CITY PLAN COMMISSION

RECORD NO.: PLAT-25-000026 (S245-190) SENIOR PLANNER: Sharmila Shrestha

REQUEST: An application to create one 2.713-acre (118,163-square foot) lot from a tract of land in City Block 7939 on property located between Clearfield Road and Prairie Creek Road, north of Fireside Drive.

PLAT-25-000026 (S245-190)

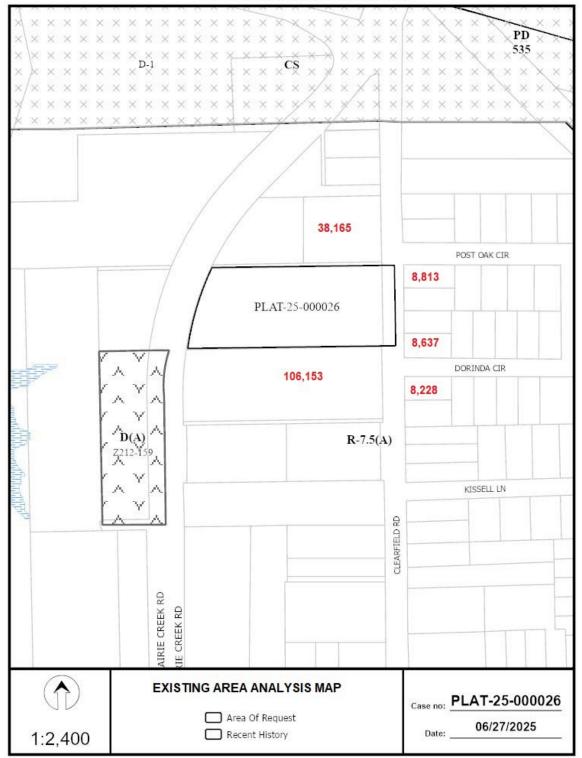
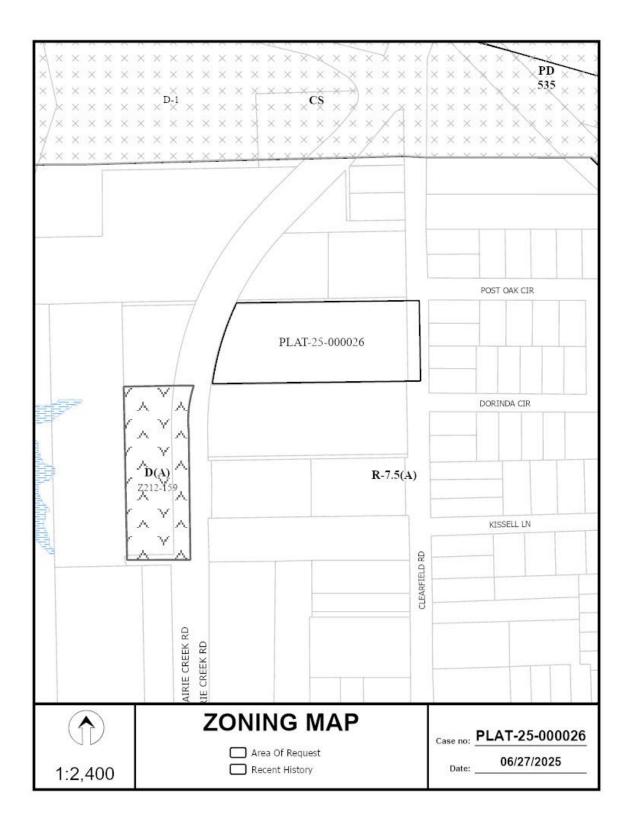
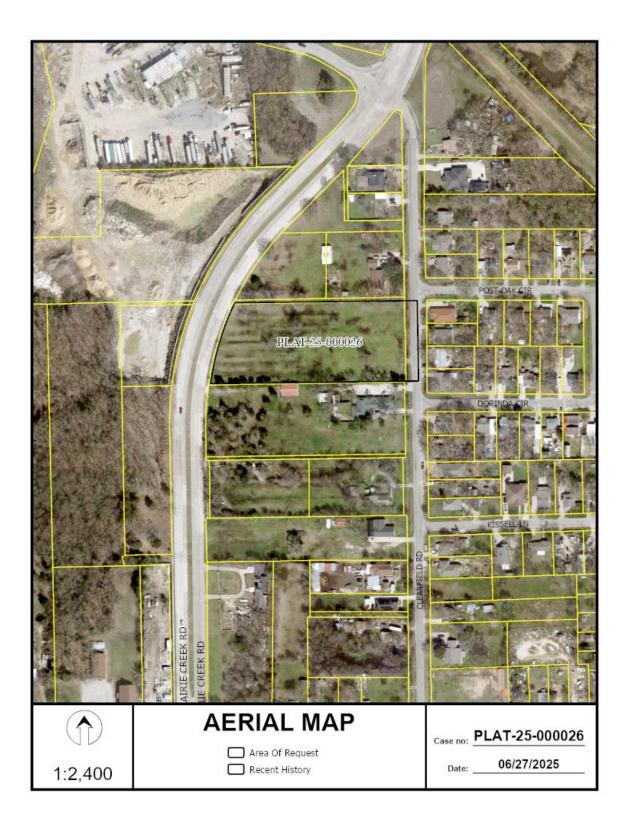
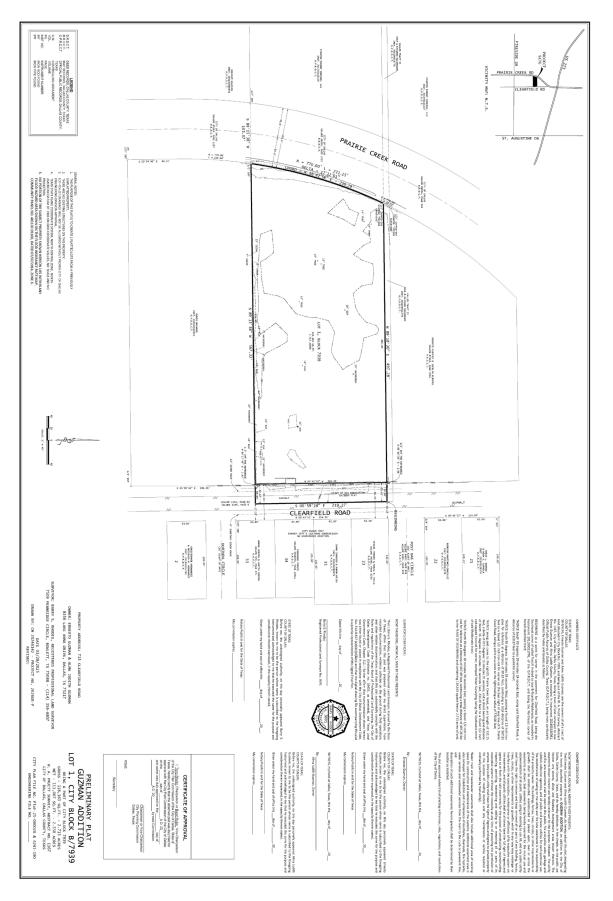
- 15. Submit a completed Final Plat Checklist and All Supporting Documentation.
- 16. Show abstract line location.
- 17. On the final plat, dedicate 3-foot barrier easement along thoroughfare.

- 18. Additional design information is required for assessment. Site plan must be submitted showing proposed development, building finished floor elevation, development, existing mains – including downstream manhole, and proposed water and wastewater service locations. Submit water/wastewater engineering plans to 320 E. Jefferson Blvd., Room 200, Attention: Water and Wastewater Engineering.
- 19. Water and wastewater main improvements are required by Private Development Contract. Submit water/wastewater Engineering Plans to 320 E. Jefferson Blvd., Room 200, Attention: Water and Wastewater Engineering.
- 20. Existing and any proposed Water and Wastewater Easements must be shown and/or increased to conform to current design standards. **Notice:** Minimum DWU easement size 20' for one utility and 25' for both water and sewer. Larger diameter or deeper mains may require additional width.

- 21. Additional design information needed to complete review. Provide a brief description of the proposed project and a copy of the preliminary plat to <u>daniel.silva1@dallas.gov</u> to determine street lighting requirements.
- 22. On the final plat, change "Dorinda Circle" to "Dorinda Circle (FKA Post Oak Circle South)".
- 23. On the final plat, change "Post Oak Circle" to "Post Oak Circle (FKA Post Oak Circle North)".
- 24. On the final plat, identify the property as Lot 1 in City Block B/7839.
